**Re: Allrite Roofing Systems, 3040 Painted Rock Drive NW, Grading and  
Drainage Plan**

**Engineer's Stamp dated 9-26-03 (G10/D29G)**

**REVISED MASTER DRAINAGE STUDY**

**Re: Allrite Roofing Systems, 3040 Painted Rock Dr. NW, Grading and Drainage Plan (G10/D29G)**

**MAXIMUM FLOW IN ROCK SWALE**

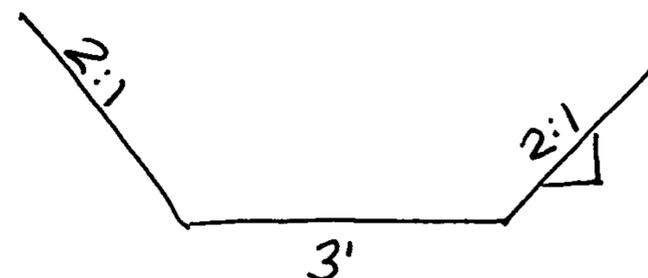
1. Address the downstream capacity of the northern swale between Painted Rock Dr. and Todos Santos St.
2. Label all easements.
3. Who is responsible for maintaining the northern and eastern swales? If the City is responsible for their maintenance, the swales must be brought up to City standards.
4. Prove quantitatively which sites are allowed free discharge.
5. Please address the size and capacity of the north and east swales if the properties upstream of the swale are allowed free discharge.

1. Appendix C contains the Manning's Equation calculations for the "Maximum Flow in Rock Swale." This section is for a trapezoidal channel with a 3' bottom width and 2:1 sides. The maximum developed flow in this rock swale occurs at the northeast corner of Tract 5A2-A1-3. At this point the combined free discharge from Tract 5A2-A1-2, Tract 5A2-A1-3, and Tract 5A2-A-4 generates a runoff of 9.67-cfs (see "100-Year Hydrologic Calculations Proposed Conditions"). This runoff will have a flow depth of 0.77' in the rock swale. This rock swale transitions into a 10' wide (1' deep) concrete channel at 2.95%. Since the flow is contained within a 3' trapezoidal rock swale at 1.60%, it will easily be contained in the steeper 10' wide concrete channel.

5. A single channel section has been designed for all of the swales for ease of construction. As described above (Comment 1), the swales have been designed to carry the combined developed flow from all three tracts of land.
